DEVELOPMENT NO.:	21039035	
APPLICANT:	Alan Cooper	
ADDRESS:	43A MARLBOROUGH STREET, BRIGHTON SA 5048	
NATURE OF DEVELOPMENT:	Three storey detached dwelling	
ZONING INFORMATION:	Zones:	
	General Neighbourhood	
	Overlays:	
	Airport Building Heights (Regulated)	
	Affordable Housing	
	Prescribed Wells Area	
	<ul> <li>Regulated and Significant Tree</li> </ul>	
	Stormwater Management	
	Urban Tree Canopy	
LODGEMENT DATE:	20 Dec 2021	
RELEVANT AUTHORITY:	Assessment Panel at City of Holdfast Bay	
PLANNING & DESIGN CODE VERSION:	4 November 2021 2021.16	
CATEGORY OF DEVELOPMENT:	Code Assessed - Performance Assessed	
NOTIFICATION:	Yes	
RECOMMENDING OFFICER:	Dean Spasic	
	Development Officer - Planning

Red outline depicts building outline of previous dwelling granted planning consent by the ERD Court in 2019

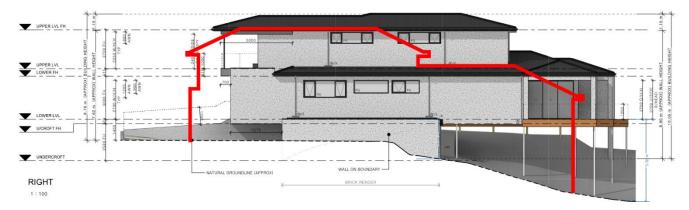
The site was subject to a previous application for a two storey detached dwelling, which was granted Development Plan Consent by the Environment, Resources and Development Court on the 18/12/2019. In terms of overall scale, the previous dwelling, although only two storeys, was similar to that of the proposed dwelling, as demonstrated on the western side elevation, below:

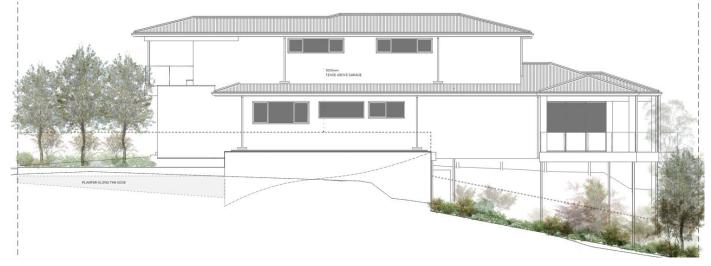
The proposed building reads as a substantial sized building from the front, western side and southern rear. At the front, the built form reflects a modern dwelling, with rendered walls and colorbond hipped roof, however at the footpath level, it presents as a three storey building, as demonstrated in the 3D views below:

The building façade comprises three storeys, which exceeds the maximum of 2 levels anticipated by the Zone. As demonstrated in the 3D views above, the three storey building has a total height that matches the approved and under construction two storey buildings immediately to the east. The levels therefore do not compromise the general built form scale, rather the third level is contained practically under the ground level of a site that is lower than the eastern neighbouring sites. The proposal is therefore considered to be not satisfy General Neighbourhood Zone, Part 2, Performance Outcome, 4.1 *buildings contribute to a low-rise suburban character ('low-rise' is defined in the Design Code as buildings up to 2 levels),* albeit by way of building below ground, matching neighbouring buildings heights and provision of quality landscaping, the proposal is considered to not be significantly at odds with this policy.

# Western side elevation

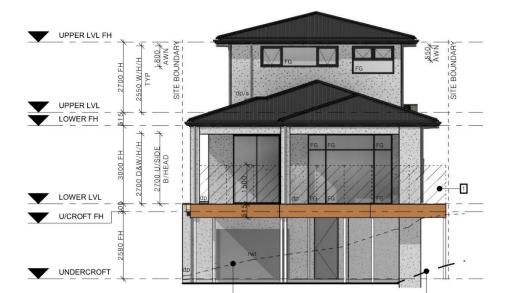
From the perspective of the western adjacent property, the building reads as a two and a half storey, however this is more so a product of the unique topography of the land, which falls downwards to the west as well as a heavy downward fall to the south. The western adjacent dwelling itself, is a two storey building whereby the rear portion is also on stilts, as opposed to stepping down with the topography of the land, which in this case, comprises a heavy fall that is not typically found within the wider locality.

When considering General Neighbourhood Zone, Part 4, Performance Outcome 8.1 which seeks to minimise the need for earthworks to limit disturbance to the natural topography of the land, it is noted that the topography comprises a heavy fall, which would result in significant costs, engineering constraints to be reasonably feasible. The use of stilts as opposed to stepping the building is evident on the western adjacent property, and is generally considered to be a reasonable alternative on difficult sites.

#### **Building Height**

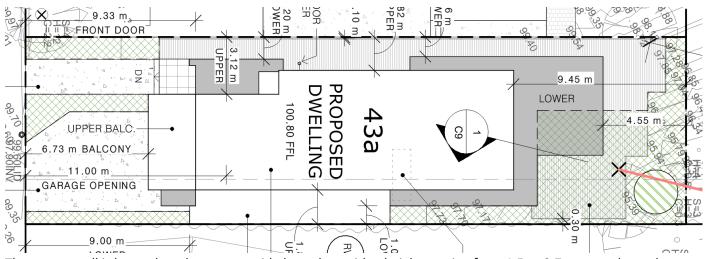
From the rear, the building reflects a two and a half storey built form (as shown below), however there is a substantial amount of existing mature vegetation in the rear yard of the southern adjacent property, which heavily screens the lower half of the building (see photos further below), this in addition with the proposed landscaping will contribute significantly to screening the proposed building.

The Design Code allows for a maximum of two building levels and maximum building height of 9 metres. The wall height should not exceed 7 metres.

The proposal comprises a building of three levels and a maximum building height of 8.9 metres at the highest point. The wall height is 6.5 metres from the footing, and up to 7.7 metres at the highest point relative to natural ground level. When considering the resulting built form and scale against the Performance Outcomes, it is considered that the proposal reasonably satisfies the fundamental objectives of achieving low-rise built form. This is further highlighted by the fact the top of the building matches the top of the eastern adjacent two storey buildings.

## Site Coverage

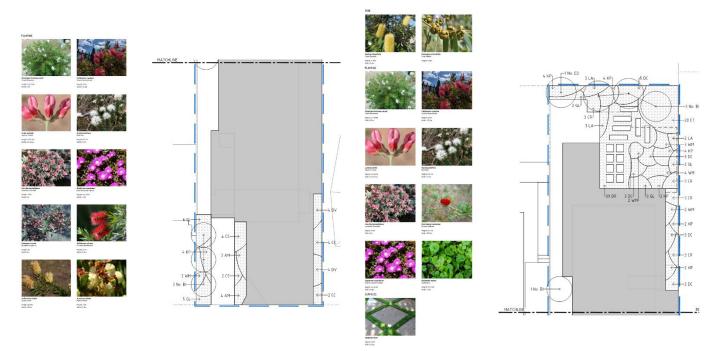
Site coverage amounts to 52 percent of the site area, therefore within the maximum of 60 percent allowed by the Design Code. The proposal satisfies General Neighbourhood Zone, Performance Outcome 3.1 in that the building footprint allows for sufficient space around buildings to limit visual impacts, provide an attractive outlook and access to light and ventilation.

## Solar Access

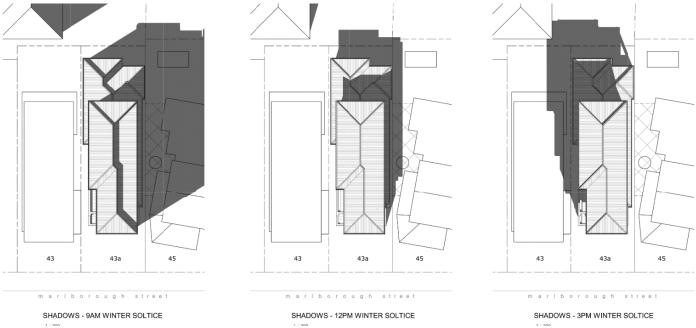
As per the shadow plans presented by the applicant, the shadow cast over adjacent properties will predominately impact on the western adjacent property, whereby north facing windows will receive sunlight all day on the 21 June. The east facing windows are demonstrated to receive more than 3 hours of direct sunlight between 9am and 3pm during the winter solstice.

It is noted that the shadow cast over the western adjacent dwelling between 9am and up until approximately 1pm is also the result of existing vegetation found on the western adjacent property, hence the proposed building is not the only source of shadowing.

The shadowing impacts are considered to reasonably satisfy General Neighbourhood Zone, Part 4, Performance Outcome 3.1, in that the proposal fails to accommodate a reasonable level of natural light to the western adjacent property.
